Kansas Department of Agriculture  
 Division of Water Resources  
**CHANGE: P/D WORKSHEET**

# DWR FIELD OFFICE APPLICATION FOR APPROVAL TO CHANGE THE PLACE OF USE AND/OR THE POINT OF DIVERSION

**SUMMARY ORDER APPROVING APPLICATION FOR CHANGE AND IMPOSING CONDITIONS**

RE: Application for Change in Point of Diversion  
Water Right, File No. 14550

**WELL TEST ANALYSIS**

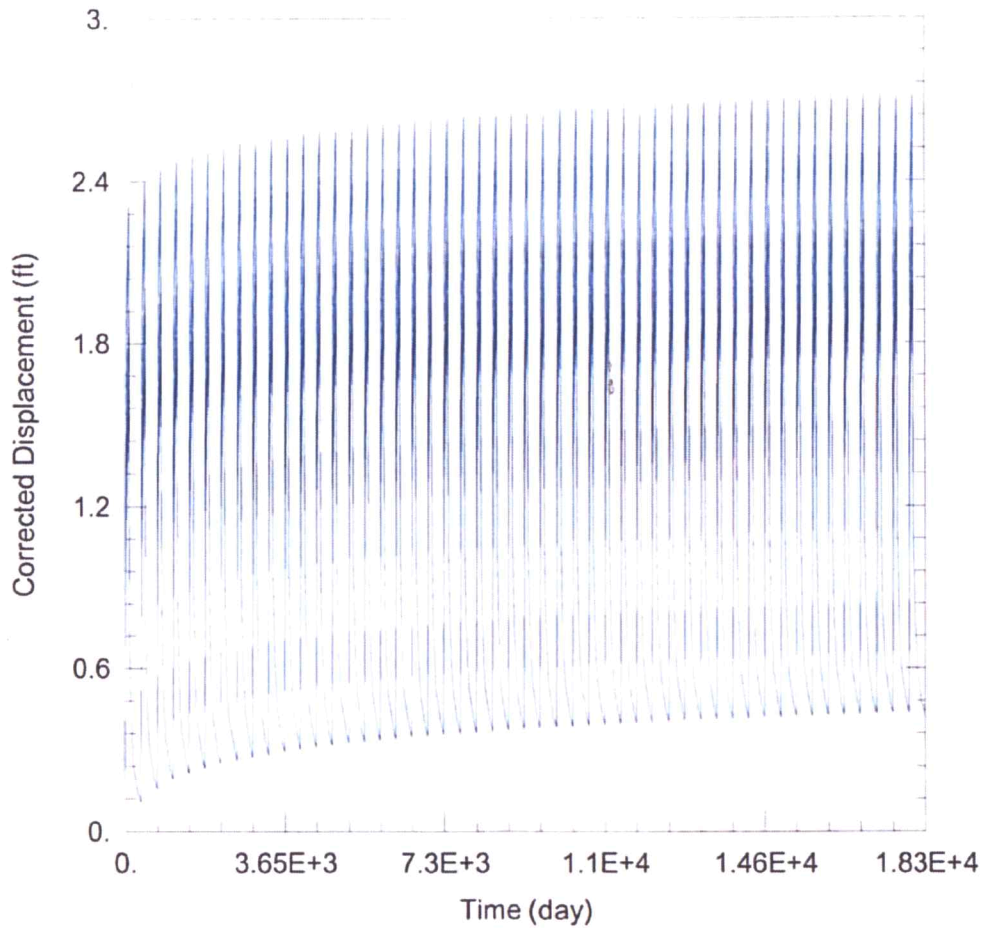
24273: Drawdown from current location = 2.03 ft  
Drawdown from proposed location = 3.66 ft  
Drawdown allowance = 2.5 ft  
Net drawdown = **1.6 ft**

14101: Drawdown from current location = 2.26 ft  
Drawdown from proposed location = 3.91 ft  
Drawdown allowance = 2.5 ft  
Net drawdown = **1.7 ft**

19809: Drawdown from current location = 2.27 ft  
Drawdown from proposed location = 3.27 ft  
Drawdown allowance = 2.5 ft  
Net drawdown = **1.0 ft**

21455: Drawdown from current location = 2.08 ft  
Drawdown from proposed location = 3.29 ft  
Drawdown allowance = 2.5 ft  
Net drawdown = **1.2 ft**

Domestic NW 12-27-29: Drawdown from current location = 2.72 ft  
Drawdown from proposed location = 3.63 ft  
Drawdown allowance = 2.0 ft  
Net drawdown = **0.9 ft**

Domestic SW 12-27-29: Drawdown from current location = 2.56 ft  
Drawdown from proposed location = 4.49 ft  
Drawdown allowance = 2.0 ft  
Net drawdown = **1.9 ft**

Domestic 13-27-29: Drawdown from current location = 1.97 ft  
Drawdown from proposed location = 3.32 ft  
Drawdown allowance = 2.5 ft  
Net drawdown = **1.3 ft**

No effects on neighboring wells exceed the drawdown allowance. Therefore, critical well analysis is not necessary.

The proposed move is likely to create minimal effects on neighboring wells. GMD3 staff recommends approval of this proposal.
